PUBLIC HEARING AND PLANNING COMMISSION MEETING

Tuesday, December 1, 2009 7:00 p.m.

SUBJECT:	Review/Recommendation on Final for the McDonalds Site Plan Located at Approximately 10180 North 4800 West
APPLICANT PRESENTATION:	McDonald's Representatives
STAFF PRESENTATION:	Greg Robinson, Assistant City Manager

McDonald's Site Plan

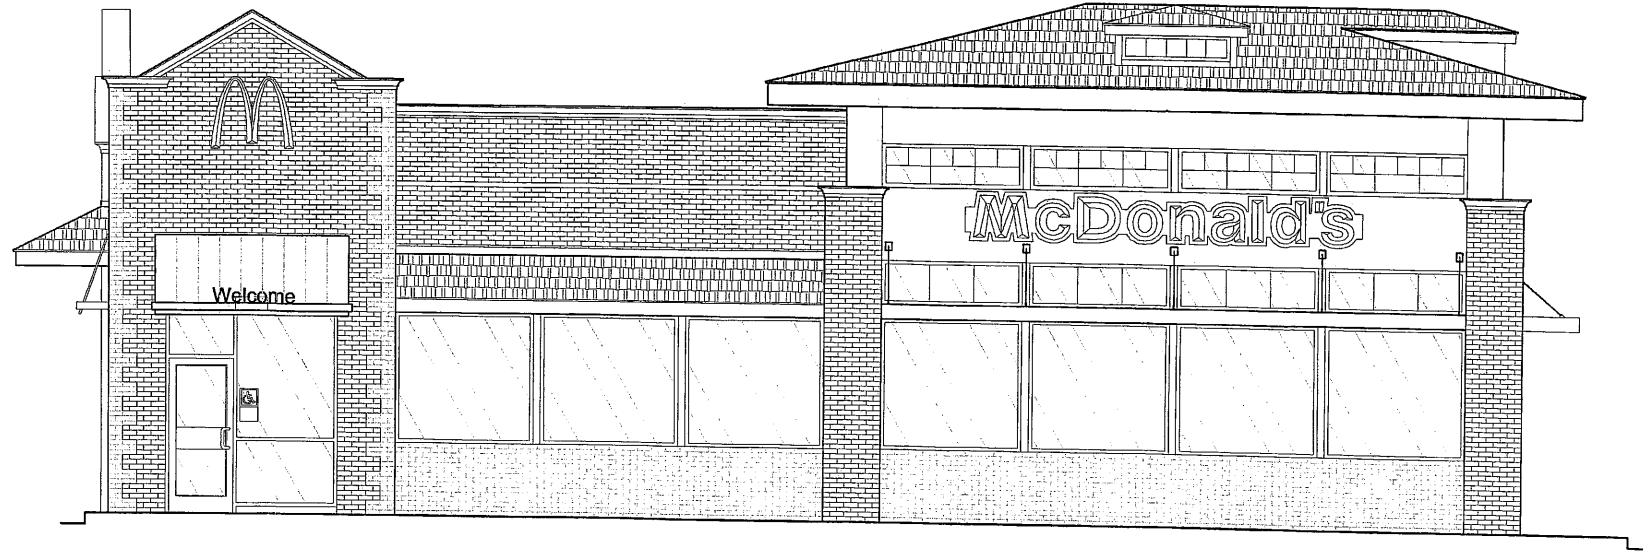
The majority of the McDonald's development is complete but there are items that the City Council wanted the developer to take care of and they are listed in previous legislative action. The elevation requirements have been addressed; the majority of the landscaping issues have also been addressed. The items that staff have not seen updates on at this point include: 1. Landscape berming, which may not be able to be shown adequately on the plans submitted. 2. The pedestrian connection between Chase and McDonald's has not been added. 3. Light box detail. 4. And the updated traffic study.

- Address shall be 10180 North 4800 West
- All fire supply lines shall be minimum main size of 8-inch
- Show cross gutter and detail for both access points from east access drive
- Show isolation valves for meter detail with bypass
- Additional sidewalk shall be included in furthestmost South East planter
